APPENDIX D
Detailed Response to Submissions

LOVELL CHEN
ARCHITECTS & HERITAGE CONSULTANTS

Figure 3 Significant views in the Domain Parklands as identified in the 2016 Context CMP
Source: Domain Parklands CMP, June 2016, vol. 1, p. 77

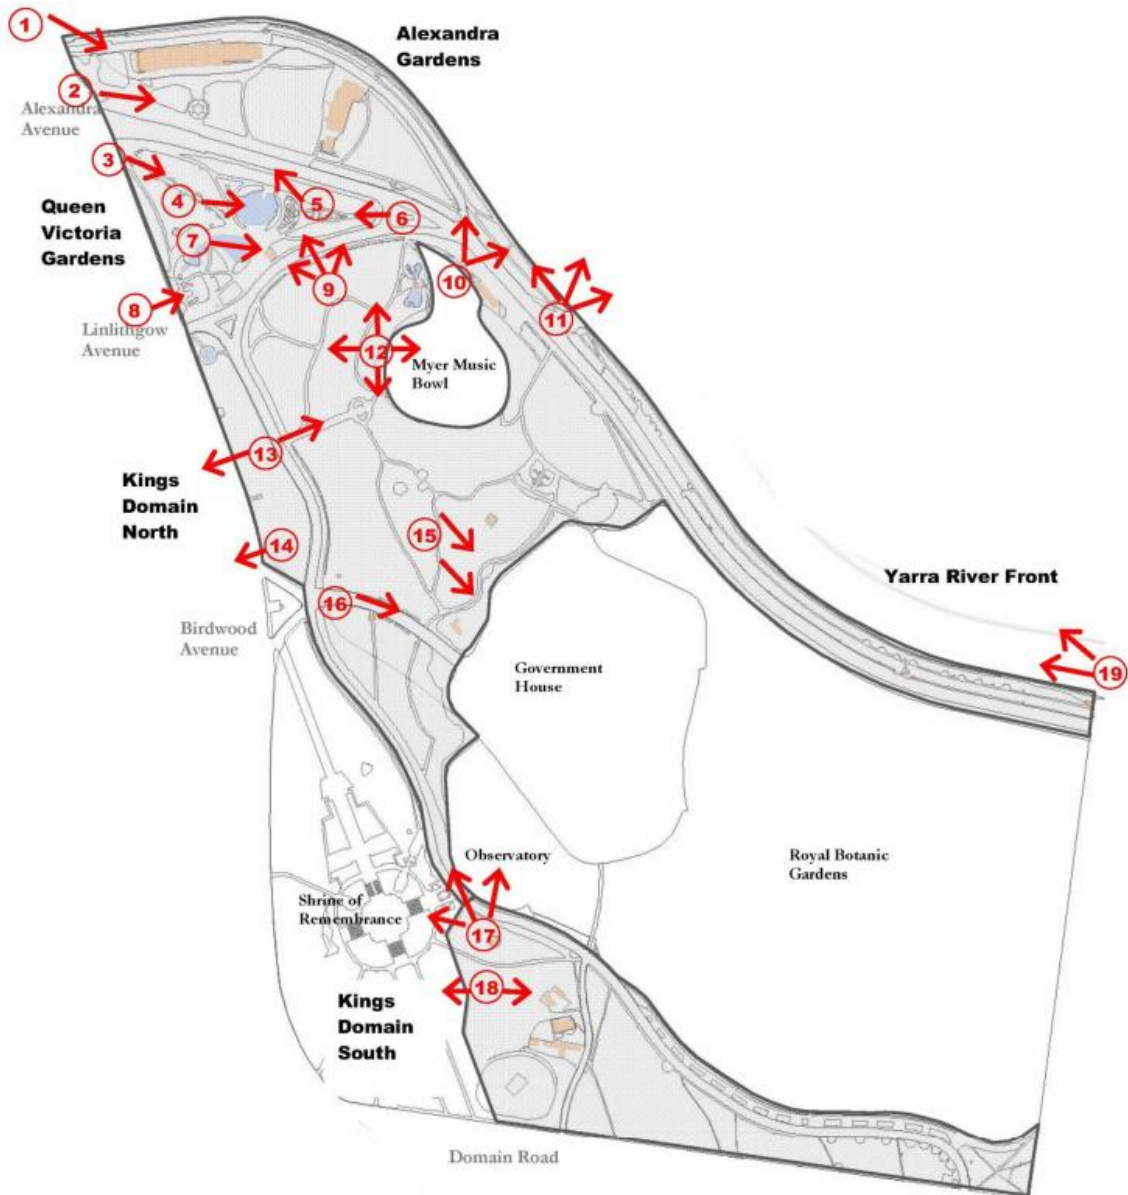
A further view, shown on the plan at Figure 3 as number 13 and described as an ‘axial vista to George V Memorial and across St Kilda Road to Grant Street’ is also identified. The ‘axial vista’ is questioned. The formal approach to the King George Memorial from Linlithgow Avenue, recently replanted with Ginkos, certainly is of significance. While in plan this on axis with Grant Street to the west, there is no corresponding pathway through Tom’s Block and no view currently available through from St Kilda Road. The CMP notes the intention was to create ‘a broad axial walk from St Kilda Road to the memorial’ however if this is the case, it does not appear to have been implemented. In my opinion this is not a significant view. I also note the view does not appear on a separate plan provided in the CMP (King’s Domain North: Summary of significance – views, p. 79, see Figure 4).

Figure 8 Melbourne and Metropolitan Board of Works plan, 1894
 Source: State Library of Victoria

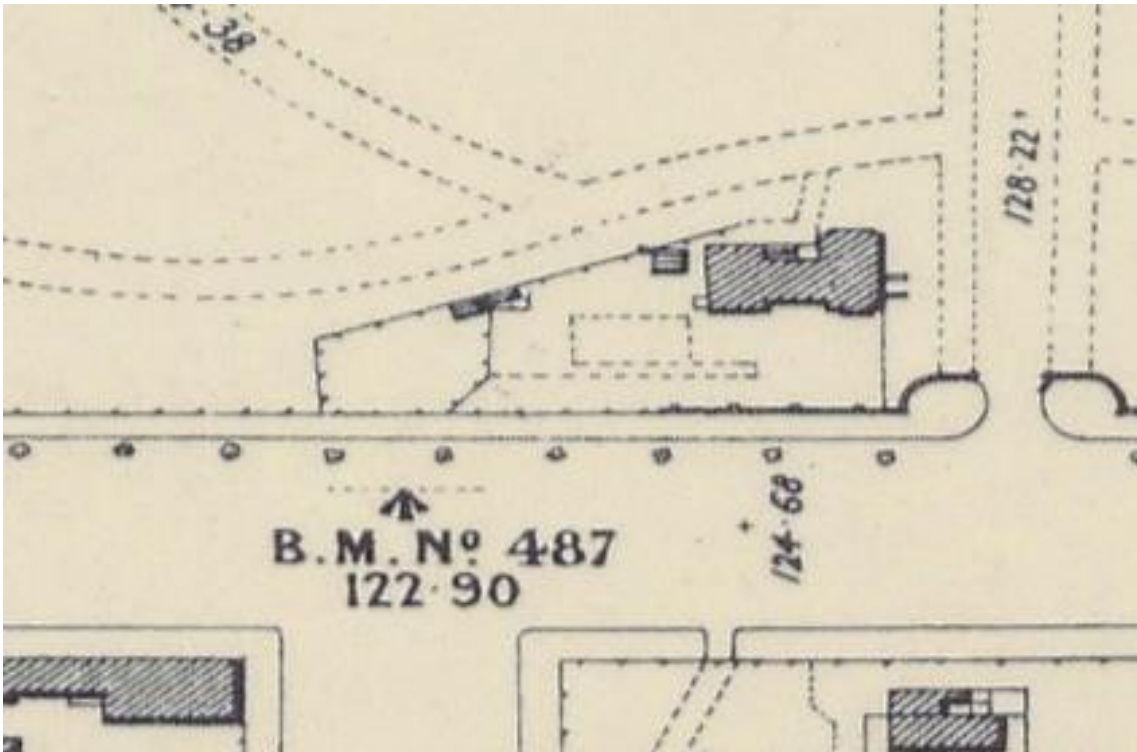
The history prepared by George Tibbits (Tibbits, 1995) references early structures on the site (including a small wooden temporary lodge (1855, damaged or destroyed by fire) and unspecified outbuildings (1850s and 1860s). Tibbits' analysis suggests that by the 1870s there was a separate kitchen outside and a water closet (Tibbits, 1995: 14-15). The MMBW plans of the 1890s show closets and a larger detached outbuilding (Figure 8, Figure 9).

Consent applications should be made for any subsurface works and an archaeological management plan will be required for the site prior to major disturbance. It is likely that works for services relocation as part of enabling works would be monitored by an archaeologist to better inform the archaeological management plan.

Figure 9 Melbourne and Metropolitan Board of Works detail plan, 1897
 Source: State Library of Victoria

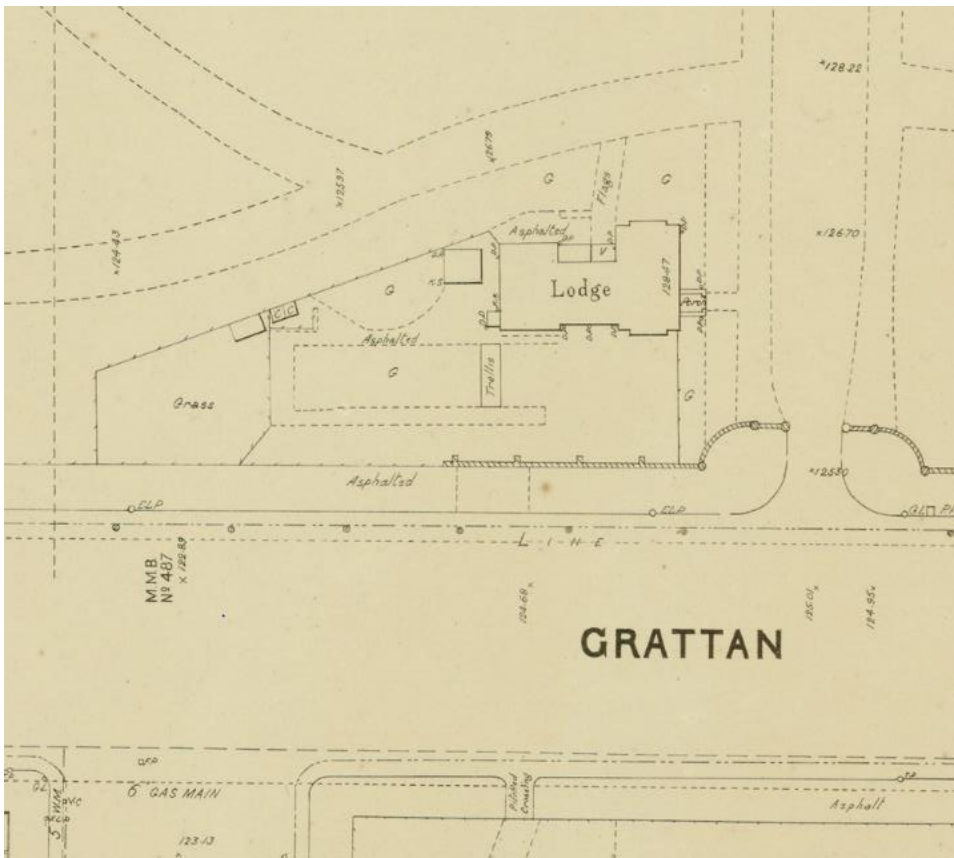
The Gatekeeper's Lodge Historical Area site is recommended for inclusion in the HI for its archaeological values (Figure 9). As such the site must be managed and protected during construction. The site is potentially subject to impacts from the proposed works, therefore the preparation of an archaeological management plan is required to manage and mitigate impacts. The archaeological management plan will be prepared in accordance with Guidelines for Investigating Historical Archaeological Artefacts and Sites (Heritage Victoria, 2014) and in consultation with Heritage Victoria.

Recommendation: Prepare an archaeological management plan for the Gatekeeper's Lodge Historical Area site.

Figure 11 Melbourne and Metropolitan Board of Works detail plan, 1897, showing the north-east corner of Grattan Street and Royal Parade
Source: State Library of Victoria

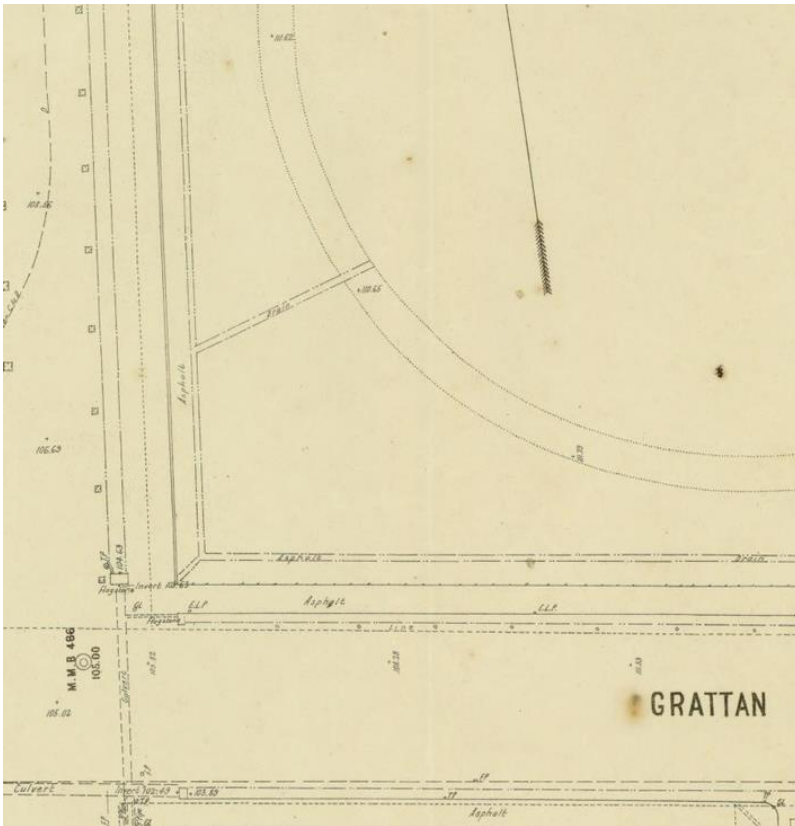
The Melbourne and Metropolitan Board of Works plans from the 1890s indicate drains in this location (most likely surface drains, one is labelled ‘asphalt’, refer to Figure 11. Oblique aerial imagery from 1942 also indicates the presence of earlier pedestrian pathways in the general area (refer to Figure 12). It appears unlikely, given the subsequent changes in landscaping, modern pathways and adjacent buildings, that there would be physical evidence of the earlier pathway remaining. It is possible that there may be physical evidence of the drains below the ground surface, however, they are unlikely to be of historical significance, and are unlikely to provide much information that is not already available from other historical and oral sources. Due to the low level of archaeological and cultural heritage significance, this area is not considered further for impacts.

As for all works, in the event historical archaeological artefacts, features or deposits are discovered during works in this area, all works must stop and Heritage Victoria must be immediately contacted. Refer to EPR CH6 which requires the development and implementation of a protocol for managing previously unidentified historical archaeological sites discovered during project works.
